MONTICELLO NUCLEAR GENERATING PLANT  
Docket No. 263 License No. DPR-22

Off-Site Shipment of Spent Fuel

RESPONSE TO NRC INFORMAL QUESTIONS  
DISCUSSED DURING MEETING WITH REGULATORY  
STAFF ON APRIL 9, 1976

FIGURE A-2

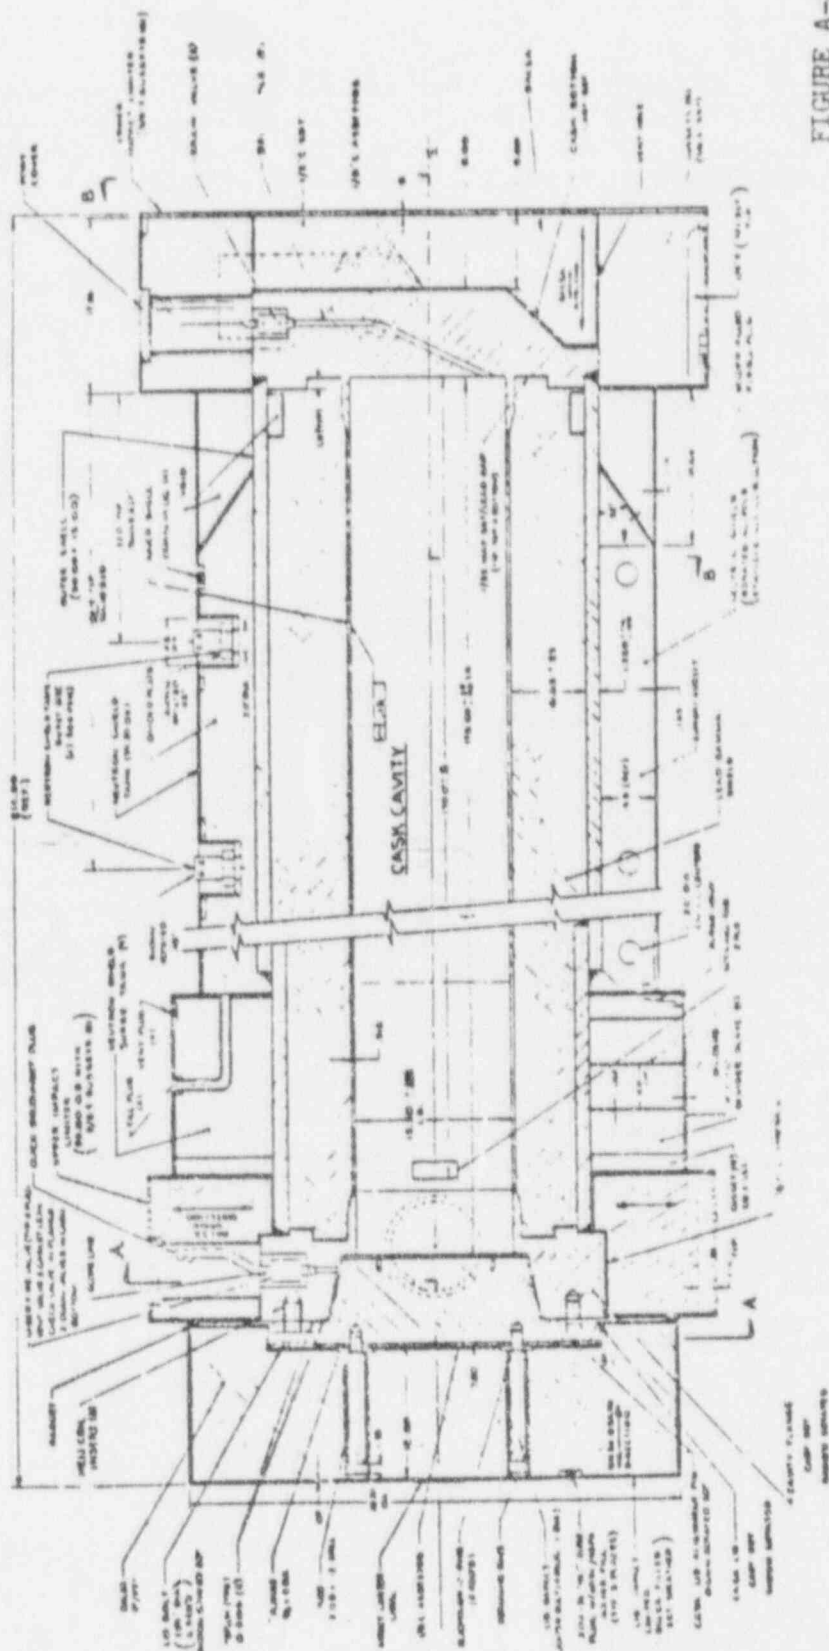
- a. Provide legible individual drawings of the shipping cask showing the lifting trunnions, the handling yoke and the twin sister hook and shackle hole.
- b. Describe and discuss the load carrying capabilities of the shipping cask lifting trunnions, the handling yoke and the point of attachment of the handling yoke to the main hoist twin sister hook.
- c. Modify Table 4-1 by adding the factors of safety for the items identified in (b) above.
- d. Describe and discuss what modifications or means are possible for devising redundant load paths from the shipping cask to the main hoist hook.

- a. Figure A-2, attached, gives a sectional drawing of the NFS-4 cask as described with lifting trunnions included. Figure A-3

The NFS-4 shipping cask is shown in Figure A-2 as submitted with the response to Question 10. The impact limiter device attached to the cask bottom head surrounds the cask body and consists of a 50 inch diameter by 17.25 inch high stainless steel ring with 3/8 inch stainless steel gusset plates filled with balsa wood for impact absorption. The impact limiter is encased in a 1/4 inch shell of stainless steel with a 1/2 inch bottom plate and a 1/2 inch shock tube for impact resistance. This design ensures maintenance of impact limiter integrity during routine handling.

FIGURE 3-7

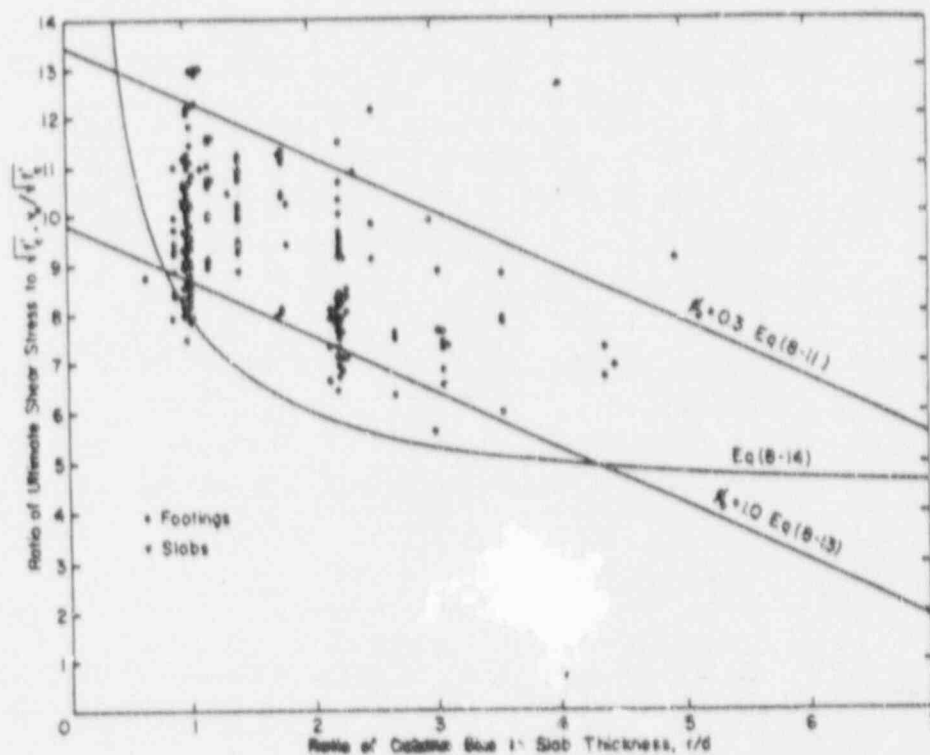
On page 3-8 it is indicated that the force acting on the structure is checked for punching shear and end shear on the slab and beam. Indicate what limits are used to arrive at the acceptance criteria.

The above conditions are satisfied by a hyperbolic equation of the form  $v_u = (Ad/r + B)\sqrt{f'_c}$ . This equation when fitted conservatively to a series of test data given in Table 8-2 of Reference 6 gives:

$$v_u = 4\left(\frac{d}{r} + 1\right)\sqrt{f'_c} \quad (8-14)$$

Comparison of this equation with an expression developed by Moe from test data (see Reference 7) is reported in Reference 6 and reproduced in attached Figure 3-7. This plot shows the validity of Equation 8-14.
